To: Manville, Jennifer[manville.jennifer@epa.gov]; Greenwater, Anthony[greenwater.anthony@epa.gov]
Cc: Dee.allen@ldftribe.com[Dee.allen@ldftribe.com]; lwawronowicz@ldftribe.com[lwawronowicz@ldftribe.com]
From: Hanson, Kristen
Sent: Tue 4/18/2017 8:11:15 PM
Subject: FW: Groundwater modeling Data
removed.txt
Haskell Lake Contimaitoin SIte EPA/Tribe Commitmment 2B, Tribal model comments submitted and incorporated
RE: proposed Haskell Lake/Tower Standard Lust Site Technical Meeting February 23, 2017

From: Hanson, Kristen
Sent: Tuesday, April 18, 2017 11:55 AM
To: 'Richard Du Bey'
Cc: Allen, Dee; 'Wawronowicz, Larry (lwawronowicz@ldftribe.com)'
Subject: RE: Groundwater modeling Data

Model 1

Figure 5: MIP-PID Response 2D Maximum

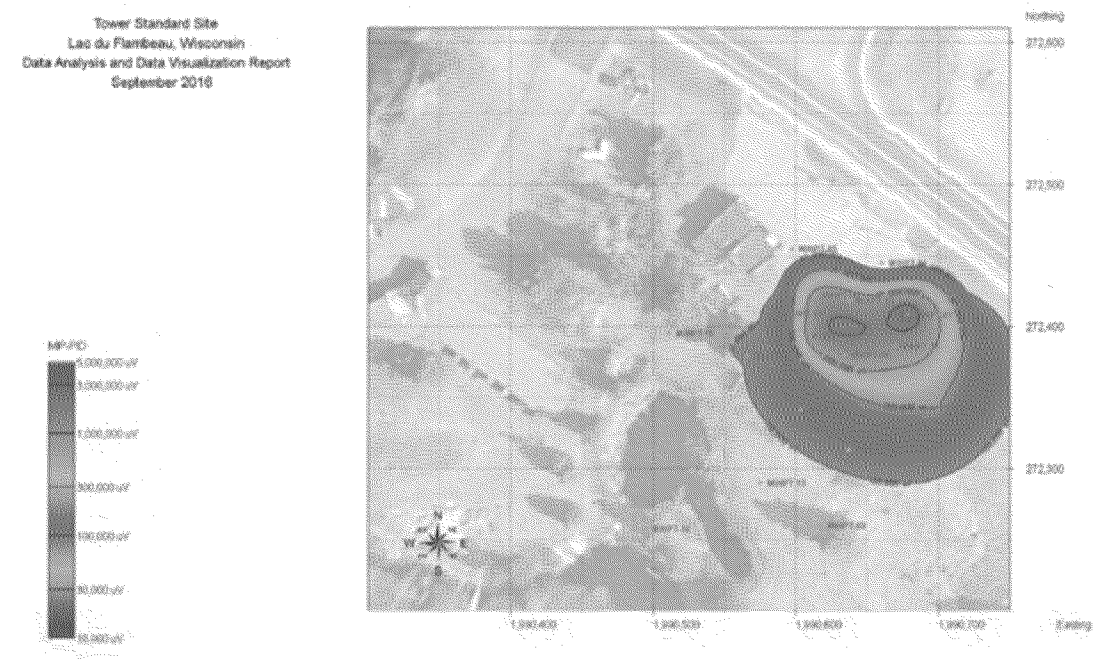
The plume shown in model 1 is based on the incomplete data set and extends further to the east than existing data suggests, does not account known site data, and does not show the plume path from the source area to the lake including the MW16 well nest.

The Area in red is known substantial contaminated groundwater plume, and is not included or represented in the graphic representation.

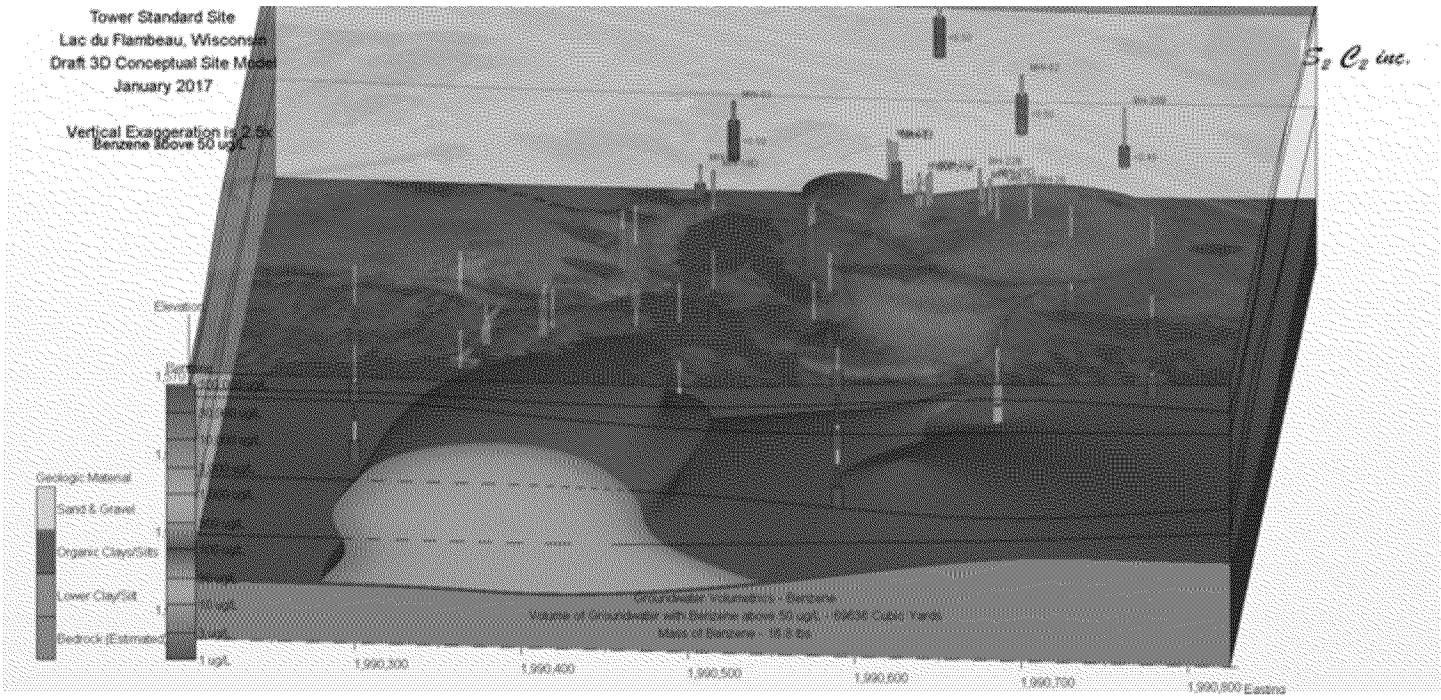
This model shows two separate plume, one near the road, and a separate plume near the lake rising from the bedrock. In many places, the model does not represent actual site data and extends the plume to the east in areas of known clean areas.

Tribal Comments include model extends further to the east than data supports

Model 2 shows 2 separate plumes, one near the road and one rising from the bedrock near the lake. This interpretation is not likely and different than what reasonable data interpretation suggests.
